ENVIRONMENTAL IMPACT ANALYSIS PROCESS

VOLUME III - PRELIMINARY
FINAL ENVIRONMENTAL IMPACT STATEMENT
CONSTRUCTION AND OPERATION OF
SPACE LAUNCH COMPLEX 7

VANDENBERG AIR FORCE BASE, CALIFORNIA
23 OCTOBER 1989

FIGURE 2.1.11

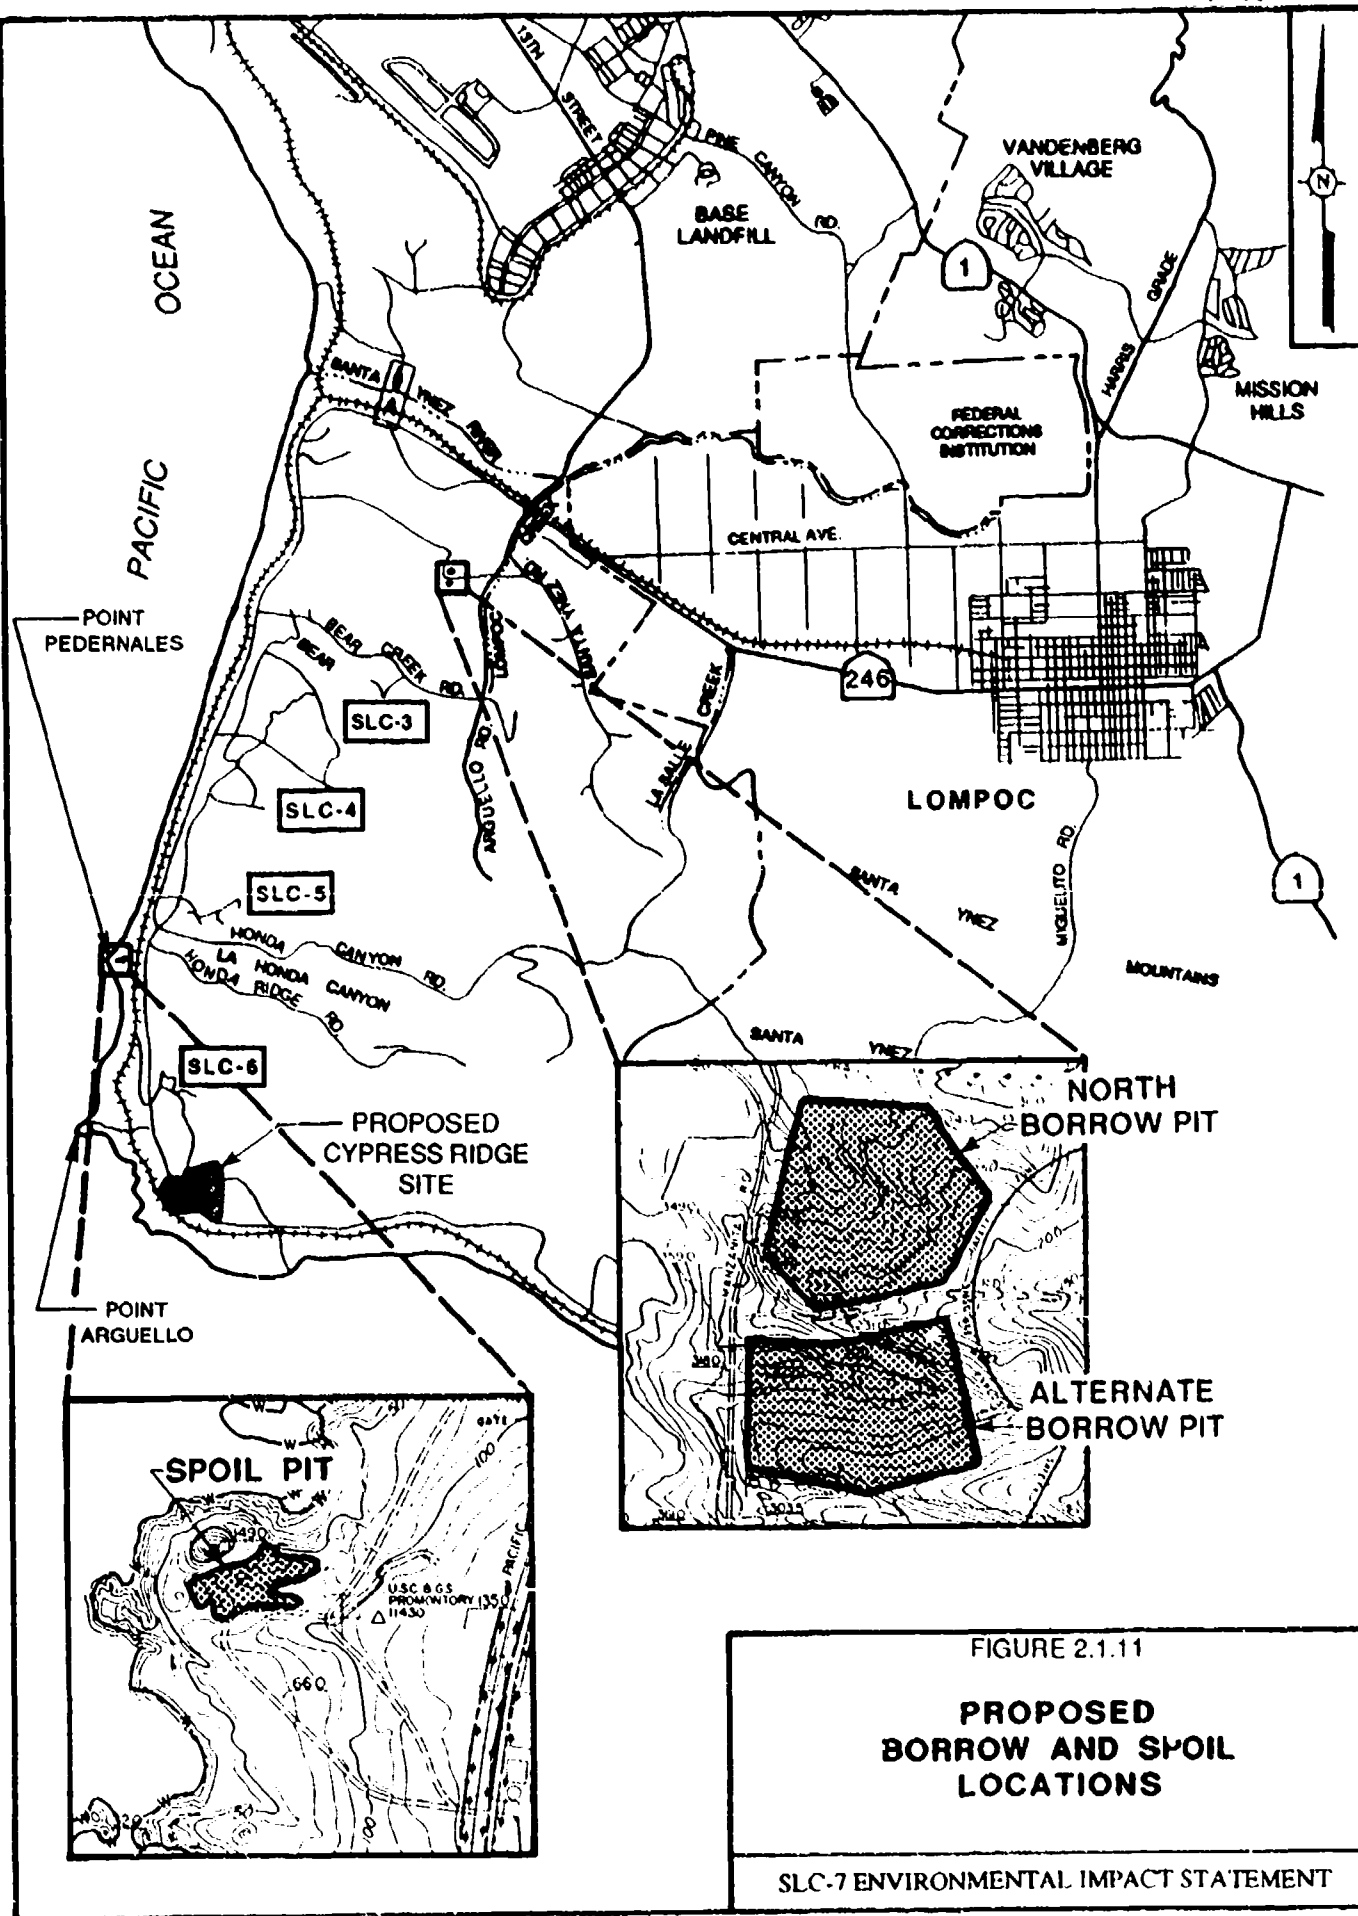
[44] Page 2-25 - More information is needed on the locations of the proposed borrow and spoil pits indicated in Figure 2.1.11. Borrow areas adjacent to the Santa Ynez River may contain riparian/wetland resources which could be impacted by borrow activity. This needs clarification.

The potential borrow pits adjacent to the Santa Ynez River are no longer being considered as areas that would be utilized as a source of material for the construction of SLC-7. Changes to Figure 2.1.11 are noted in Section 3.0 of this Final EIS.

Section 2.1.4.1, page 2-25, Drawing changed for Figure 2.1.11.
